SERVICE BULLETIN

APPLICABILITY: 2017-18MY Forester 2.5L

NUMBER: 09-84-22R

SUBJECT: Exhaust Pipe Front (EPF) Replacement &
Warranty Extension

Description of Changes:

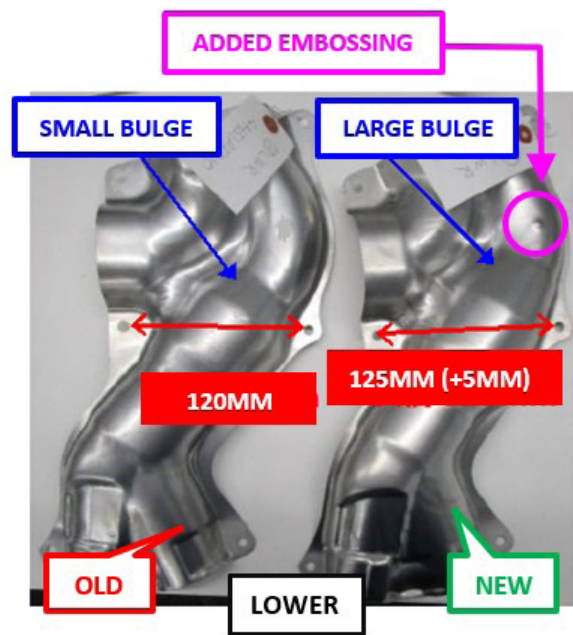
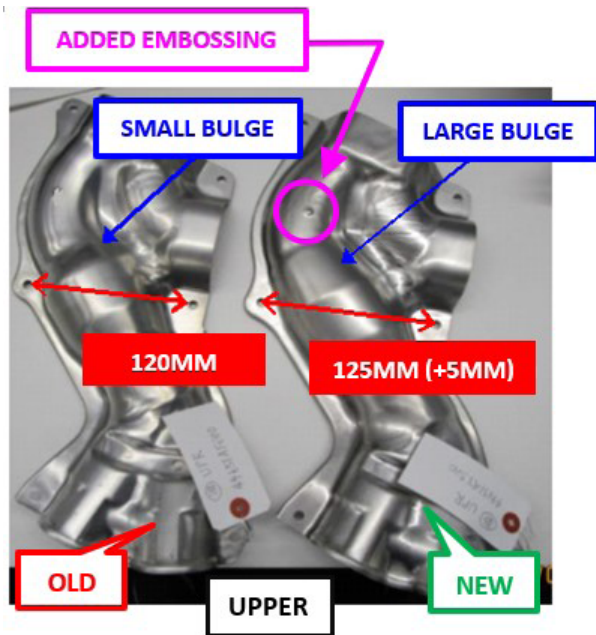
Part Description	Number	Areas of Change	Details
Front Exhaust Pipe (CONVERTER COMPLETE-FRONT)	1	Bellows	Material Change
	2	Holder	Re-Shaped
	3	Upstream Holder	Re-Sized
	4	Downstream Holder	Re-Sized
	5	Upper Elbow	Re-Shaped
	6	Lower Elbow	Re-Shaped
Upper Cover (COVER COMPLETE-CONVERTER PIPE FRONT)	7	Upper Cover	Re-Shaped (Described Next Page)
Lower Cover (COVER COMPLETE-CONVERTER PIPE FRONT)	8	Lower Cover	Re-Shaped (Described Next Page)
